MODEL
2019-2020MY
Sedona (YP)

NUMBER
194 (Rev 1, 12/06/2019)

TECHNICAL SERVICE BULLETIN

SUBJECT: SERVICE ACTION: TAILGATE GAS LIFT INSPECTION
AND/OR REPLACEMENT (SA398)

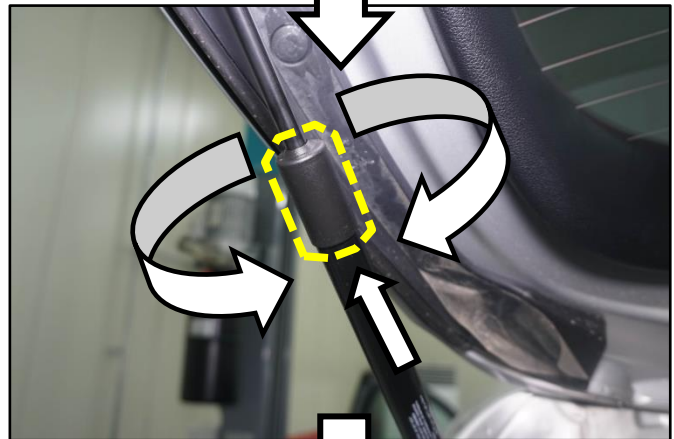
1. Open the tailgate door and locate the gas lifts (A).

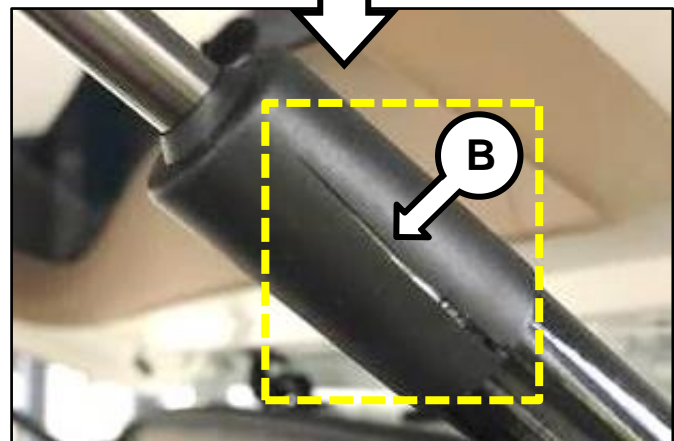
2. Inspect both of the tailgate gas lift dust covers (B) for:
 - Visual cracks (image shown).
 - Fails to turn/spin.
 - Fails to disengage upward.

If the tailgate lift dust cover(s) (A) is/are faulty, proceed to step 3.

3. Remove the tailgate gas lift(s) by referring to the “Body (Interior and Exterior) → Tail Gate → Tail Gate Lift → Repair procedures” chapter in the applicable Shop Manual on KGIS.

4. Install all removed parts in the reverse order of removal.
